## **TOWN OF BELLINGHAM CONSERVATION COMMISSION**

To: Conservation Commission  
From: Hannah Chace, Conservation Agent  
RE: Prospect Hill Village (DEP file No. 108-968) – Oulying Discussion Points  
Date: July 22, 2025

RE: Prospect Hill NOI Peer Review (DEP File No. 105-0968)  
Off Lake Street/Prospect Street  
Assessors Map 69, Lot 87/Map 65, Lots 20, 22, 22-01 & 22-02  
Bellingham, MA

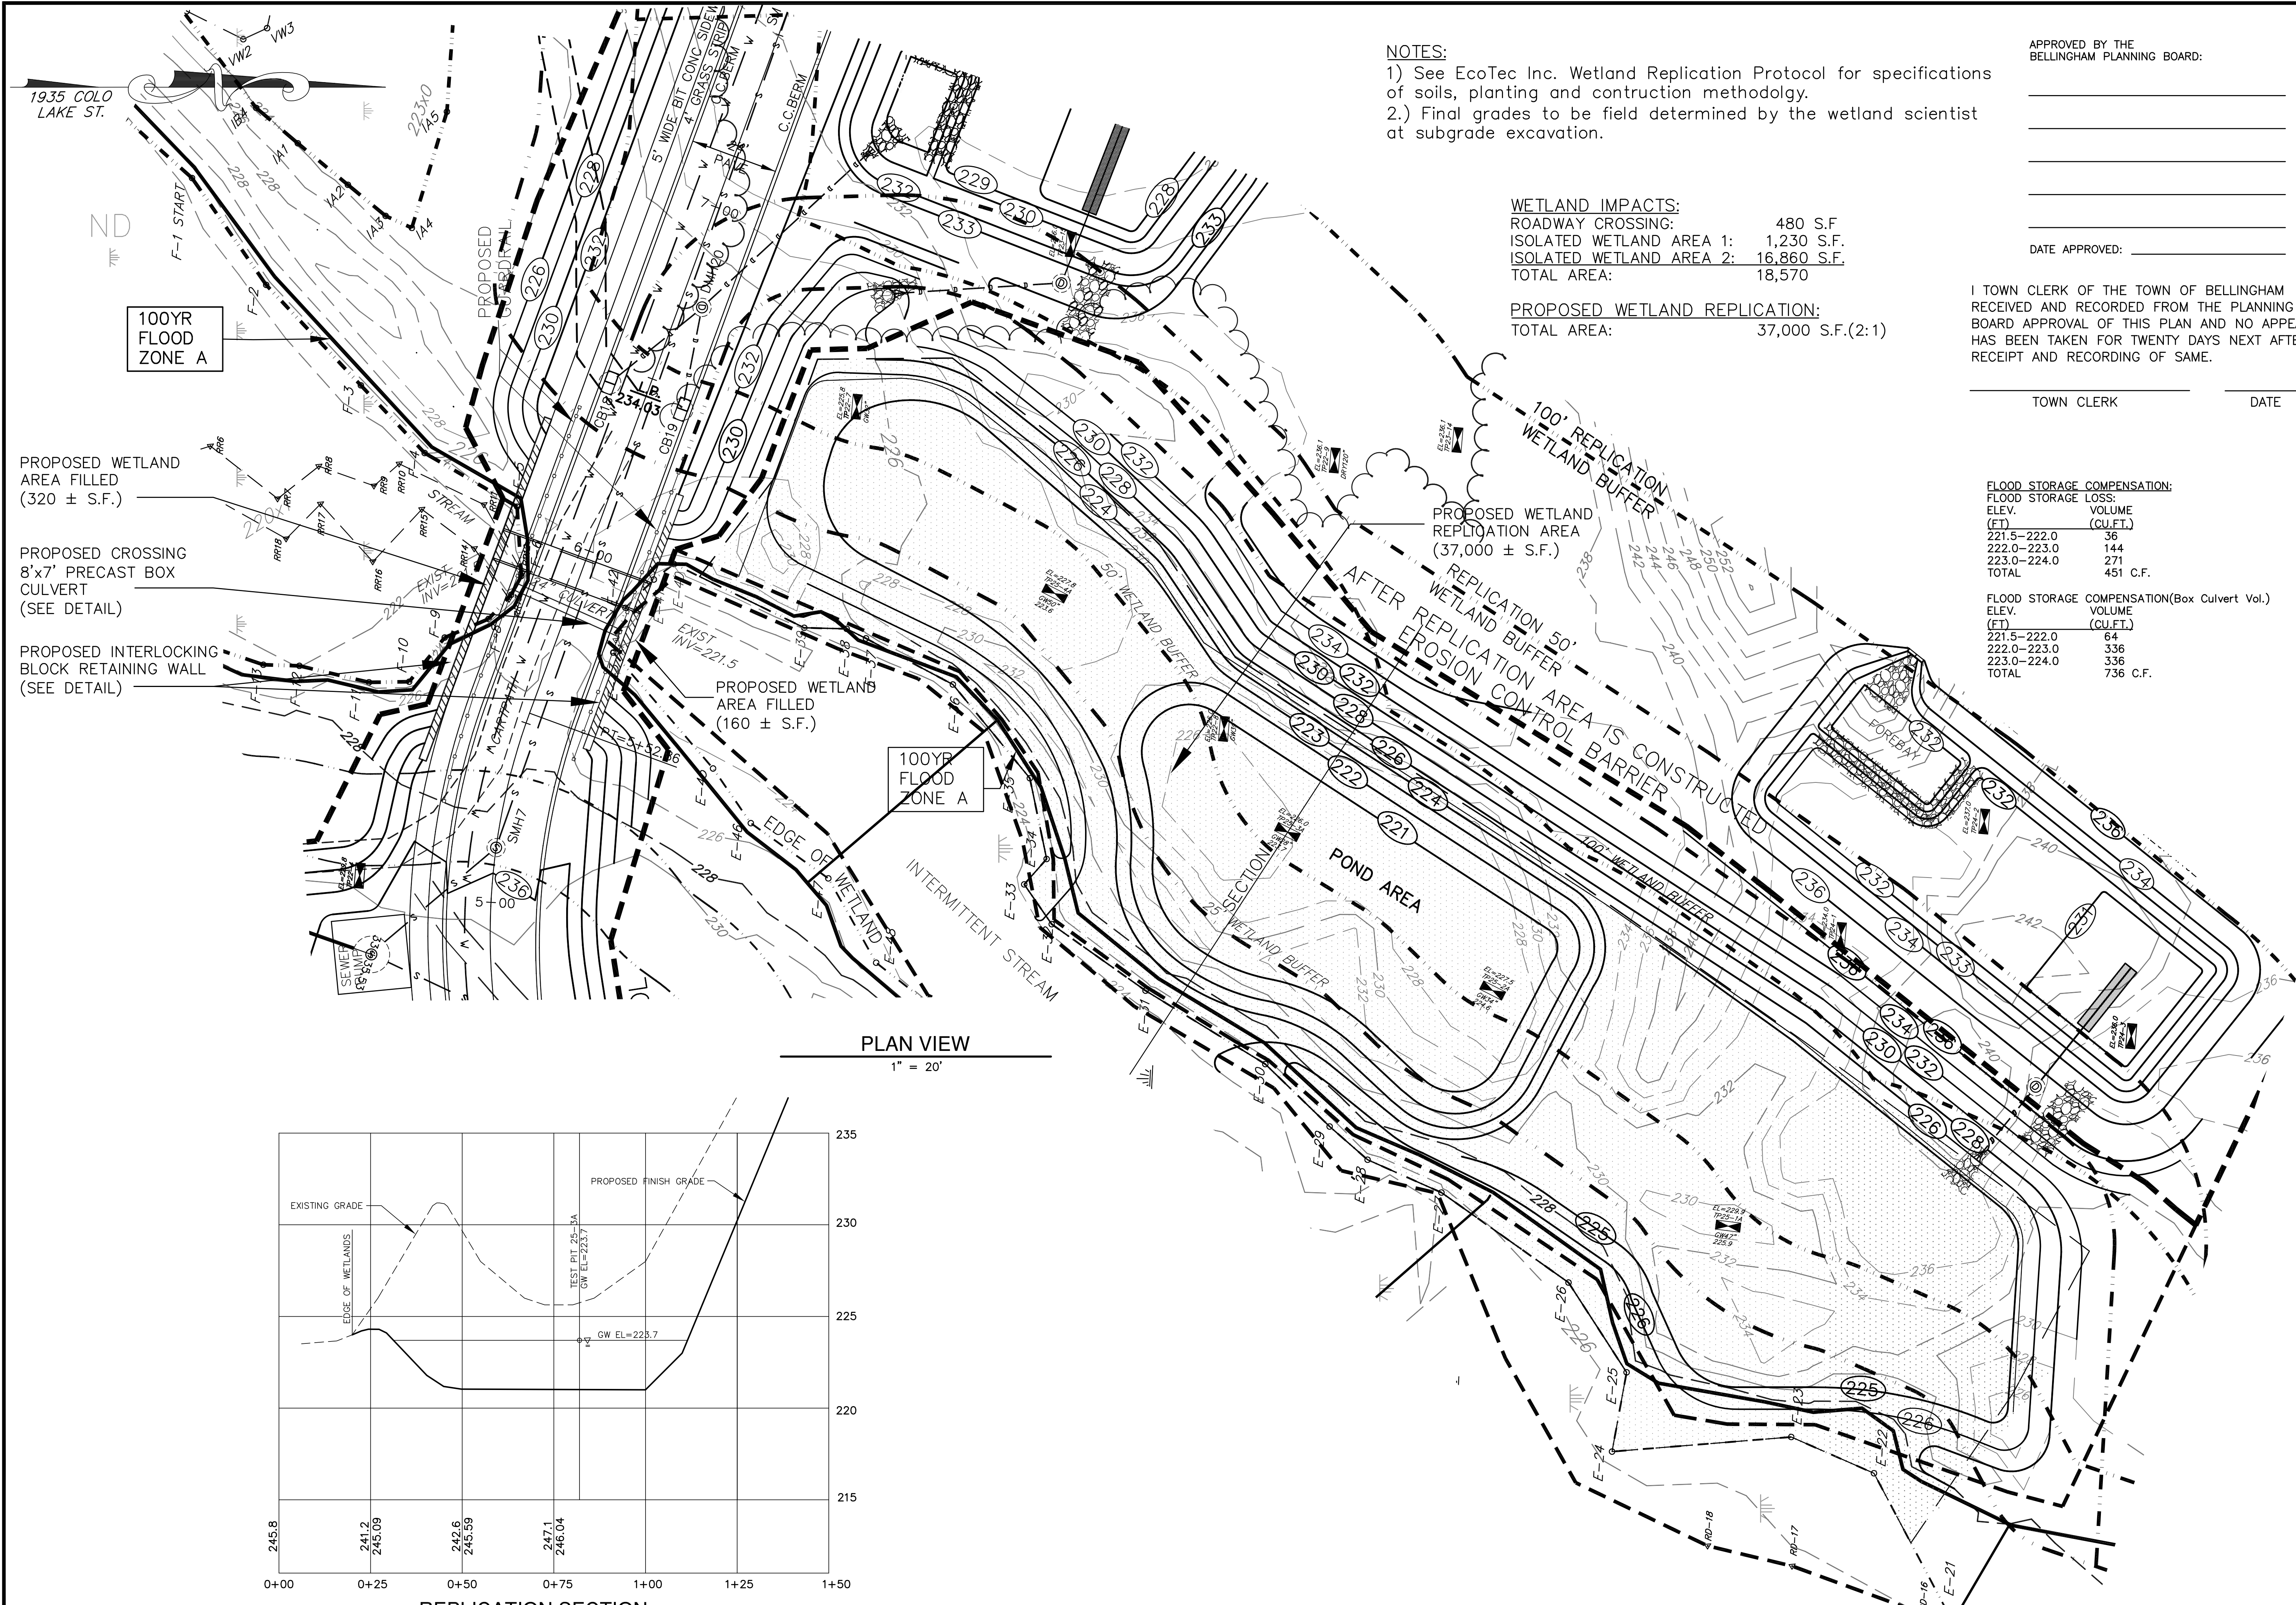
1. Revise the planting plan to include a restoration or tree saving plan within the buffer zone to the replication area between Drainage Basin #1 and Drainage Basin #2 (sheet SUP -A attached).

- o This measure was as identified by the applicants representative Rob Truax during the second working group meeting as a buffer zone mitigation measure. This would help mitigate for the substantial loss of buffer zone from the proposed filling of two isolated vegetated wetlands and to ensure there is naturalized and vegetated buffer to protect the proposed wetland replication area. The applicant is altering 131,893 square feet of isolated wetland buffer zone in addition to the buffer zone associated with BVW, where the replication area is proposed. The applicant does not show a restoration plan for the replication area's buffer zone including those areas within the 25' NDZ and the commissions typical 50' no structure/temporary alteration zone. No description is given for those area within the 100 foot buffer zone not proposed as a drainage basin other than seeding/ stabilization.

- o This measure was not implemented in the response to the original staff memo/ working meeting. The wetland replication buffer zone outside the two proposed stormwater basins should be revegetated to reflect a natural condition.
